Conservation Commission AGENDA

RE: NOTIFICATION OF WETLANDS PROTECTION ACT FILE NUMBER

This project has been assigned the following file # : WE 087-0712

Site Plans

LEVEL SPREADER DETAIL

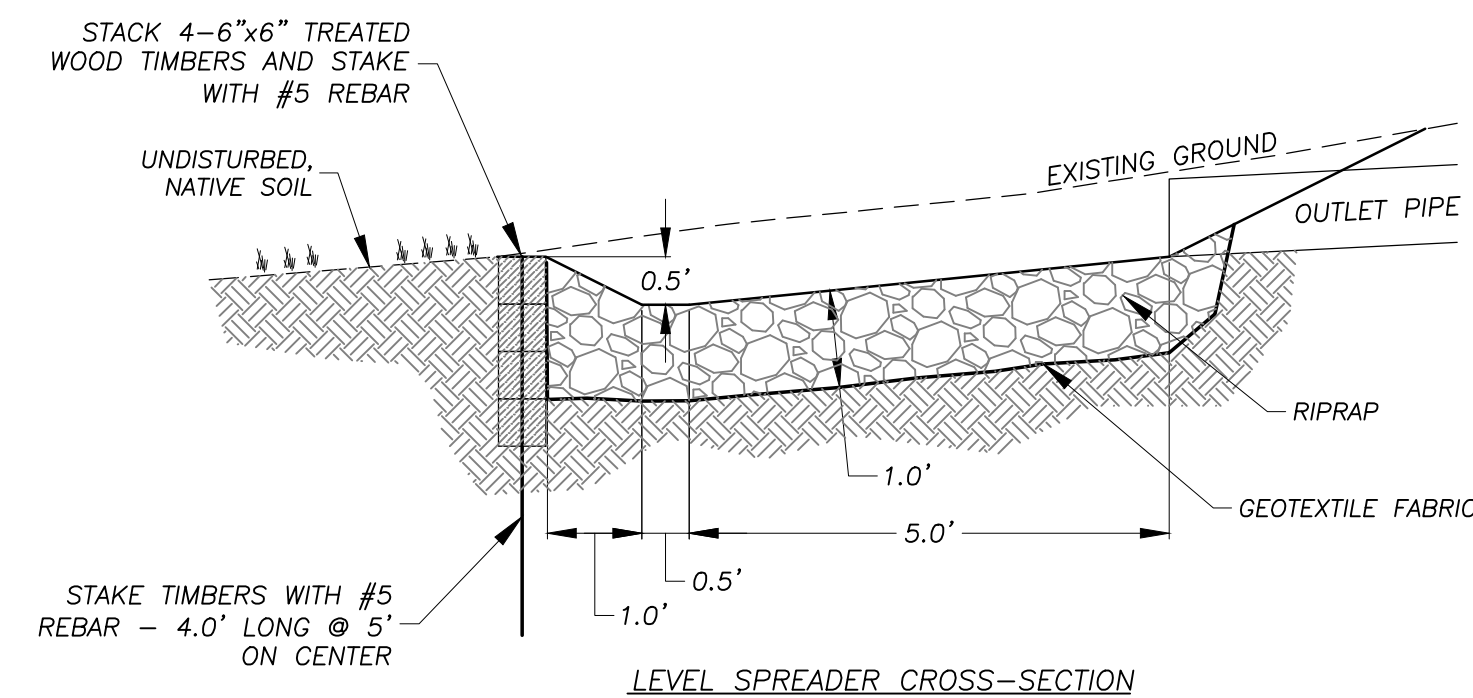
[1] in order to prevent a point source from being created, the level spreader must be maintained. At a minimum, it should be designed and constructed per the design specifications in the stormwater management handbook, Volume 2, Chapter 2.
